Ref: FCC Class II Permissive change for FCC ID:2AG69LV5XXN

Applicant:PowerFleet Inc.

This is to request a Class II Permissive change for FCC ID:2AG69LV5XXN originally granted on 03/07/2023. The change under this application is for the following reasons:

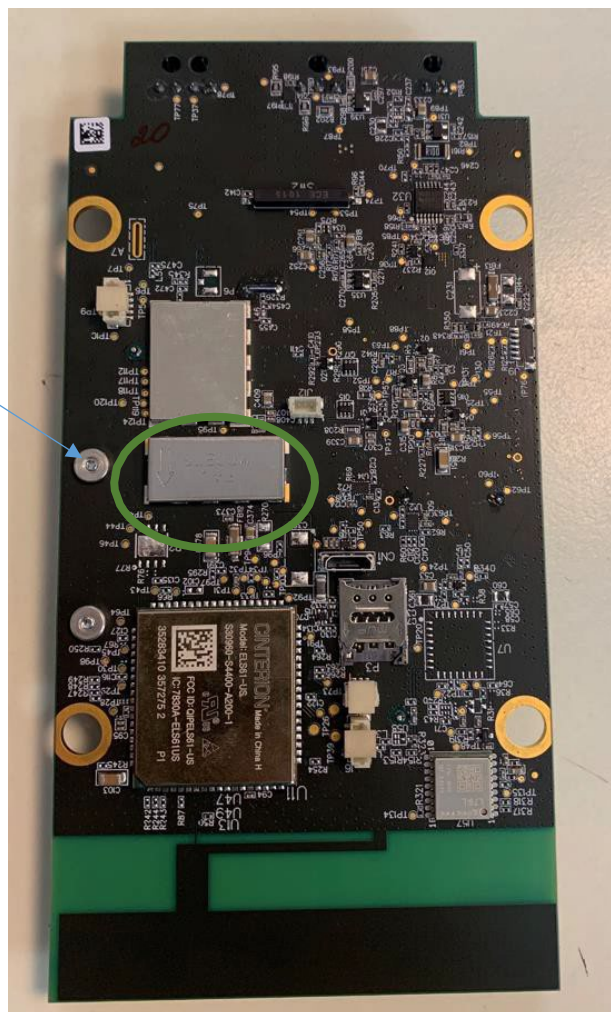
1. Added Iridium satellite modem which works only as RX if Cellular modem communication isn't available.
2. We added to the layout dedicated power components dedicated to Iridium modem.
3. Change product name and model number

Iridium Modem and Its antenna

Capacitor part of Iridium modem
